**Comment : Figure 145-15 pages 144 and 145.**

This comment is about Primary Alternative dual-signature semi-independent PSE state diagram and the proposal discussed over mails for the need to allow LCE after class probe as we did for SSPD.

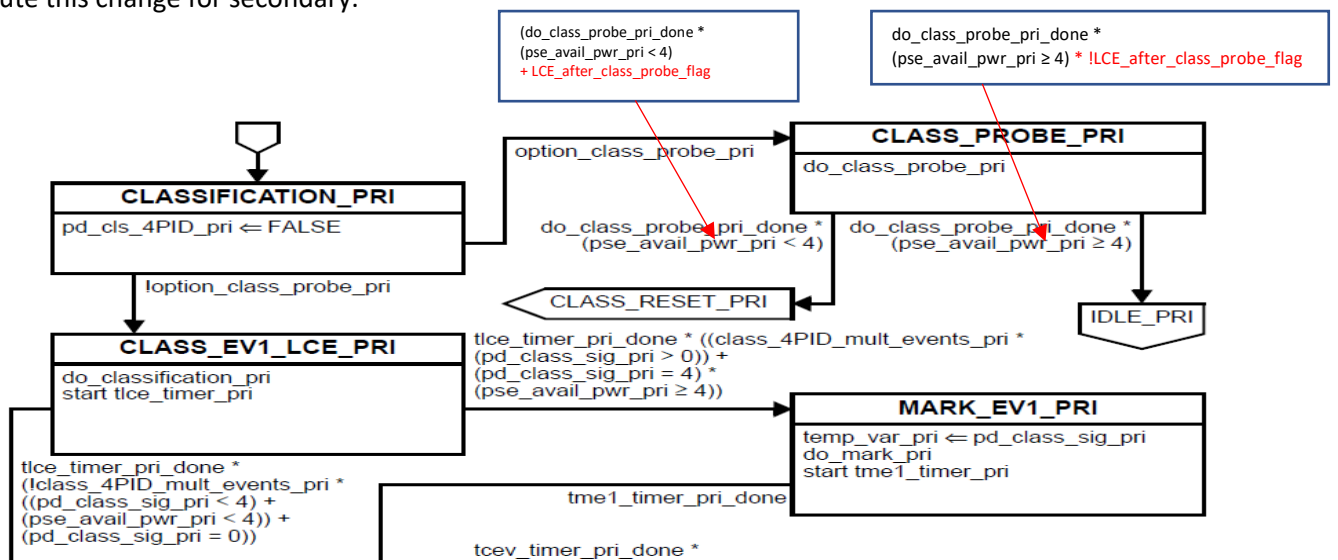
The following proposal is almost similar to Chad's proposal with the following difference:

It allows to keep the current state machine but if user which to allow the above objective, he needs to set a variable to be true to set this option.

**Proposed Remedy for page 144**

1. Add variable and make the following changes in the state machine

LCE\_after\_class\_probe\_flag

An optional variable to allow CLASS\_EV1\_LCE\_PRI after CLASS\_RESET\_PRI.

2. Repute this change for secondary.
